**DEVELOPMENT FACILITATIVE TEAM (DFT)**  
**Code Enforcement Comments**

**PR-2023-009382**

**SI-2024-00739 – SITE PLAN DFT**

**REQUEST:** FBT requests approval of DFT package for permit for Cibola Loop Multigenerational Facility

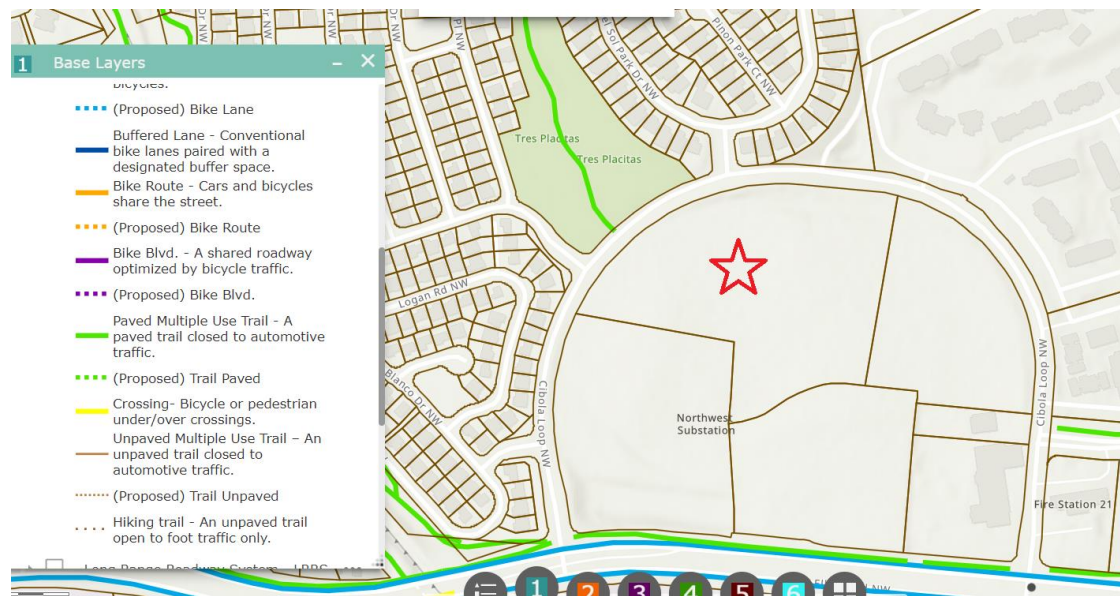
A paved multiple use trail is located adjacent to the site. Provide information regarding connection of this trail to the community center. Please see the image below for your reference.

FBT Response: At the request of Parks and Rec, the sidewalk to the facility from Cibola Loop has been redesigned to align with the existing bike trail to the west of the site. The site plan contained in the DFT submittal has been revised to reflect the alignment.

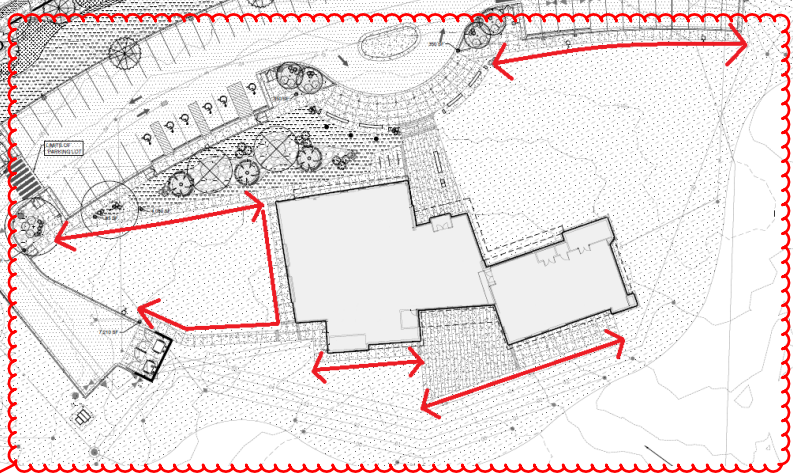
CONSIDER SEEDING

ADD 10-12 LARGE CANOPY TREES

- As mentioned in the previous sections, provide shade trees along pedestrian walkways per 5-3(D)(3)(a)3.:

These areas are reserved for future expansion. We recommend maintaining as designed.

FBT Response: Areas along pedestrian walkways are reserved for future phases.
